Project	IEEE 802.16 Broadband Wireless Access Working Group < http://ieee802.org/16 >	
Title	Action items from Session #43 and new introductory material for the Working Draft (802.16h-06/015)	
Date Submitted	2006-07-20	
Source(s)	Paul Piggin NextWave Broadband Inc. 12670 High Bluff Drive San Diego CA 92130	Voice: 858 480 3100 Fax: 858 480 3105 ppiggin [at] nextwave.com
Re:	Recirculation of Working Group Review of Working Document 80216h-06 015	
Abstract	This document contains 1) Suggested remedies to action items from session #43 from Working Group Review 2) New material pertaining to the introductory sections of the Working Draft.	
Purpose		
Notice	This document has been prepared to assist IEEE 802.16. It is offered as a basis for discussion and is not binding on the contributing individual(s) or organization(s). The material in this document is subject to change in form and content after further study. The contributor(s) reserve(s) the right to add, amend or withdraw material contained herein.

Action items from Session #43 and new introductory material for the Working Draft (802.16h-06/015)

Figure 1 Flowchart algorithm for specific spectrum users.

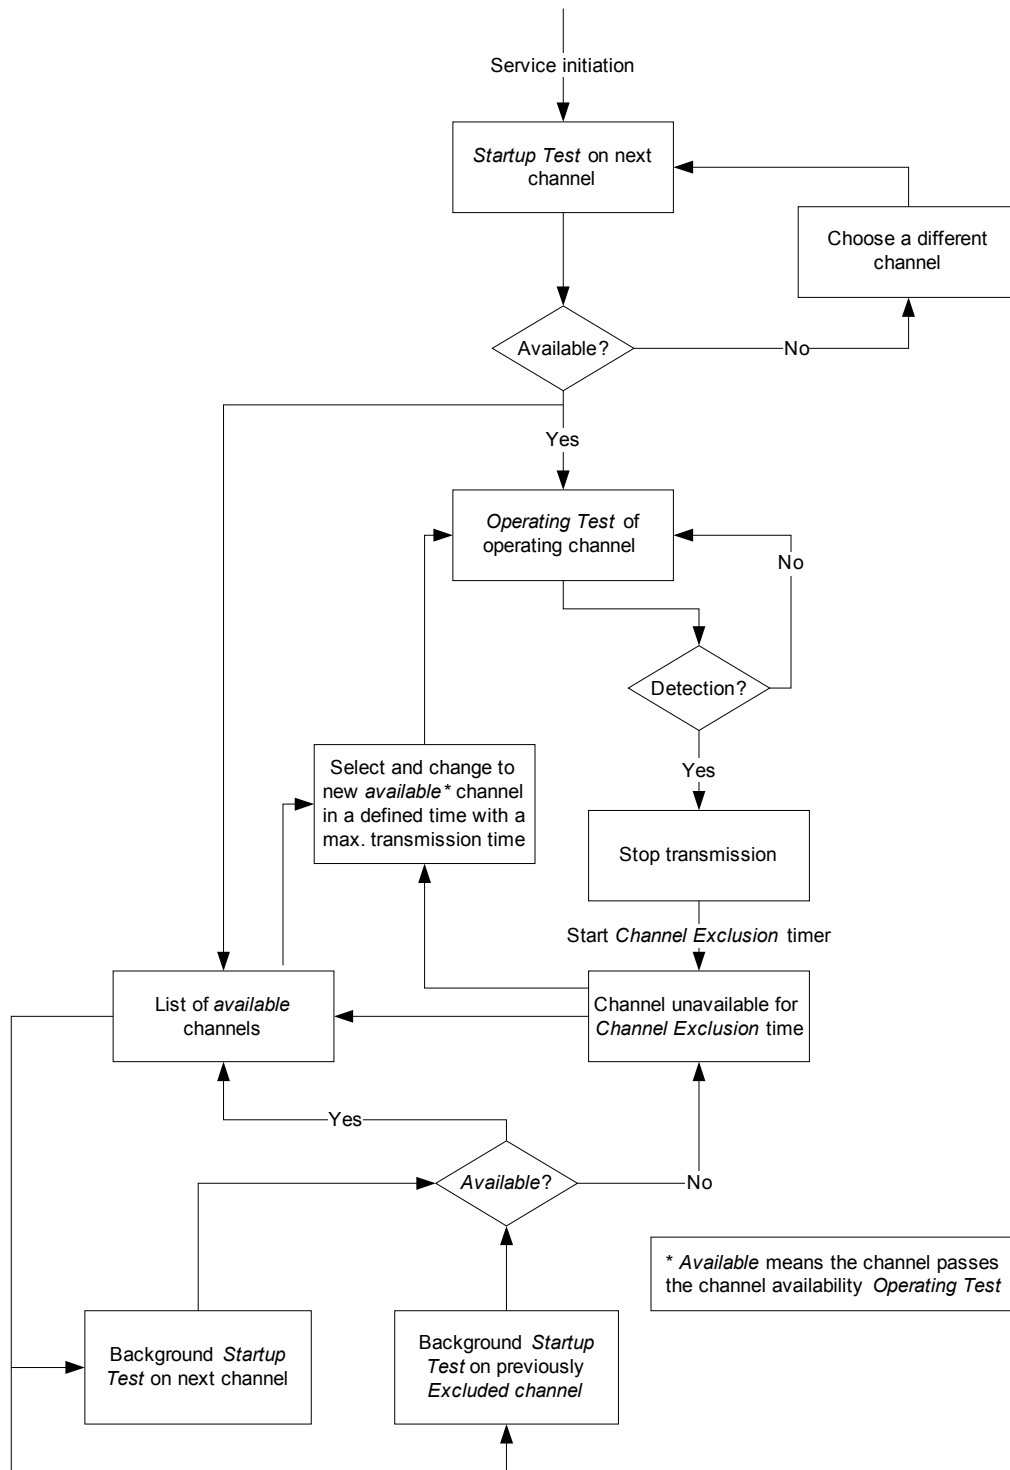
- 1) Suggested remedies to action items from session #43's Working Group Review, namely
Comment 26 of [2] – Correction of document figures.

Figure 1 provides the replacement figure for the flowchart algorithm for specific spectrum users. This is Figure h1 in section 6.3.15 of [1].

Figure 2 Representation of extended channel numbering structure.

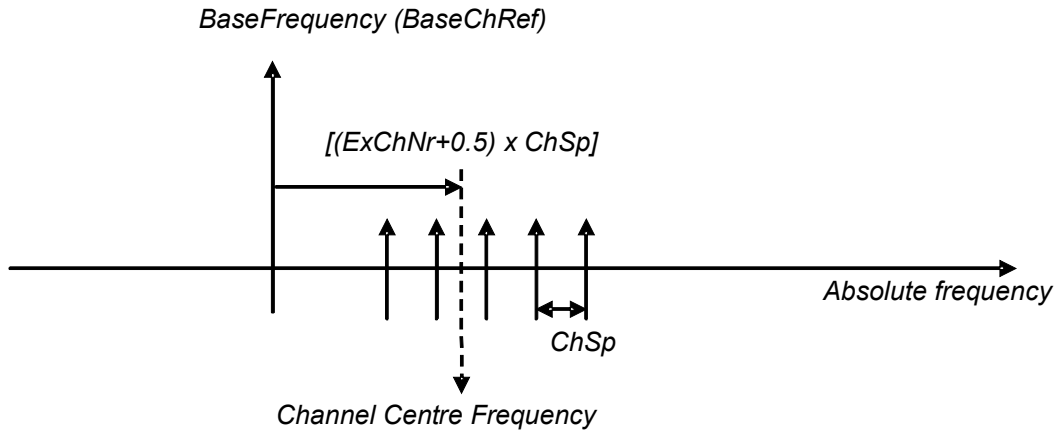
Figure 2 provides a replacement figure for the extended channel numbering structure. This is figure h2 in section 6.4.1.2 of [1].

Figure xyz Link level representation of DCS operation: (a) interference and remedial action at the BS, (b) interference and remedial action at the MS/SS.

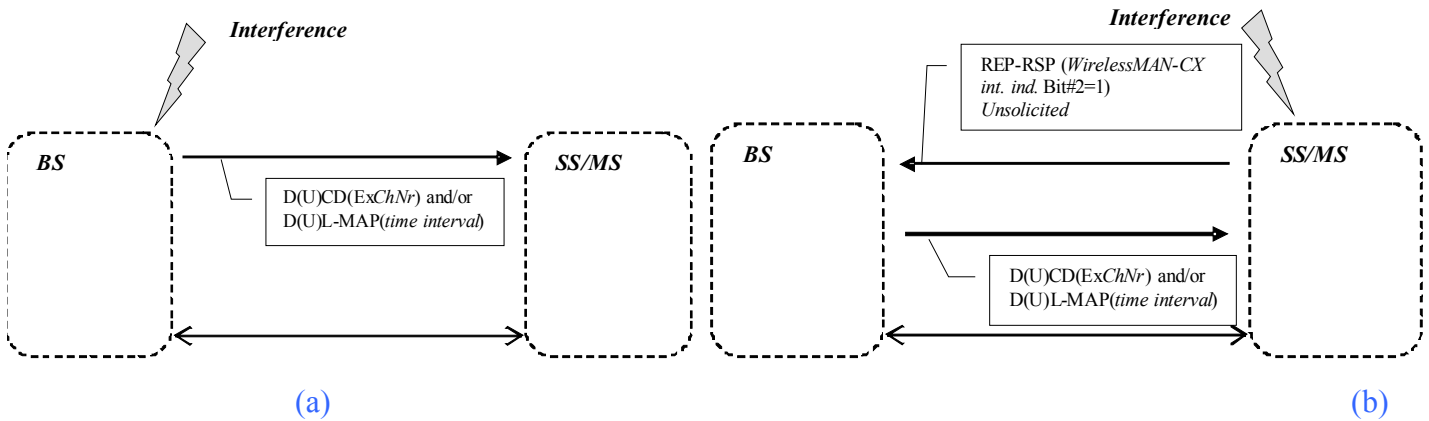
[A general example of a DCS solution is provided in figure xyz in which interference detection provides agility in frequency and time to reduce the affects of the incident interference. Figure h1 \(section 6.3.15.1\), although for specific spectrum users, provides a further example of how DCS can be used to provide resource management.](#)
